Verification Report

008

GCL - Clarendon Road PHASE 3

DATE: 22/01/2021

VERIFICATION ITEM ONE

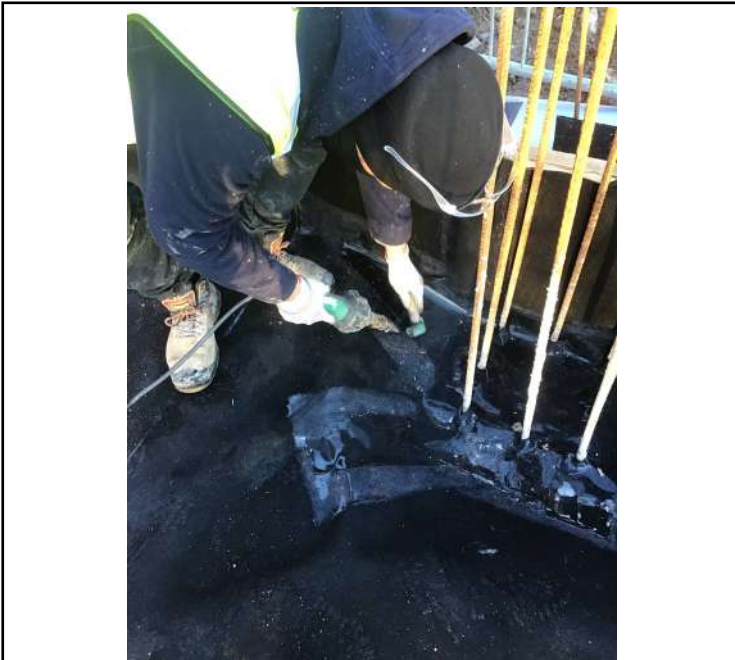
The first photograph below shows the installers using a hot air leister and roller to weld the laps of the Pudlo GP Ultra+ Gas Barrier. The installers have achieved a 40mm weld on all laps of the membrane.

The second photo above shows a pick and probe test carried out to a welded lap.

No faults or defects identified. Verified in accordance with CIRIA 735.

VERIFICATION ITEM THREE

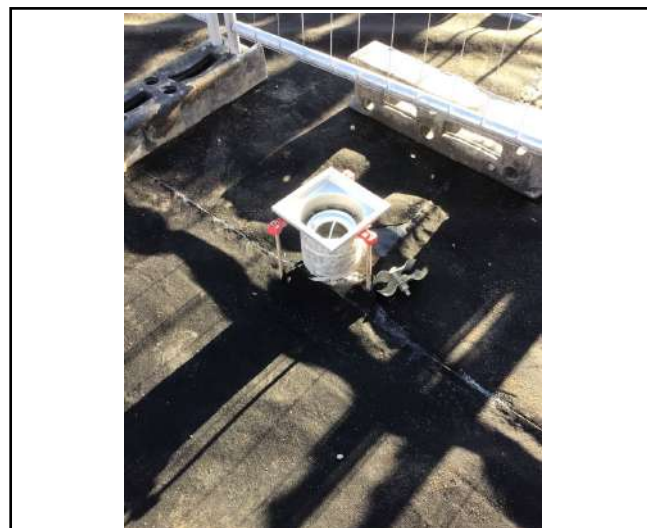
The two photographs below show outstanding penetrations of the Pudlo GP Ultra + Gas Barrier located in Block D1 pour 3. These penetrations will have to be sealed and verified during the next visit.
